# UNITED STATES PATENT AND TRADEMARK OFFICE

10/549,251

<b>Office Action Summary</b>	<b>Application No.</b> 10/549,251	<b>Applicant(s)</b> SASAKI ET AL.	
	<b>Examiner</b> PHILLIP A. JOHNSTON	<b>Art Unit</b> 2881

***Detailed Action***

**FIG. 10**

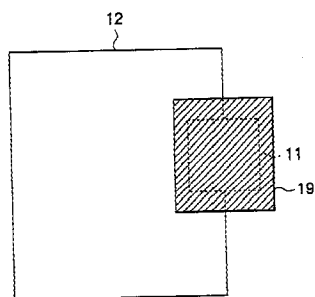
(a) Detecting the magnetic field generated by the beam in detection loop 12 using superconducting sampling circuit 11 (a magnetic field sensor),

(b) Shielding sampling circuit 11 with superconducting ground plane 19 (a shielding part), as shown in Figure 10 below. See Col. 13, line 7-35,

11. Regarding claim 12, the combination of Hidaka and Ueda discloses the use of a ground plane to shield the sampling circuit as described above regarding claim 1, which one of ordinary skill in the art would interpret from Figure 10 above as also including a space or gap in the assembly of the shield in order to reduce magnetic coupling or interference with the sampling circuit.
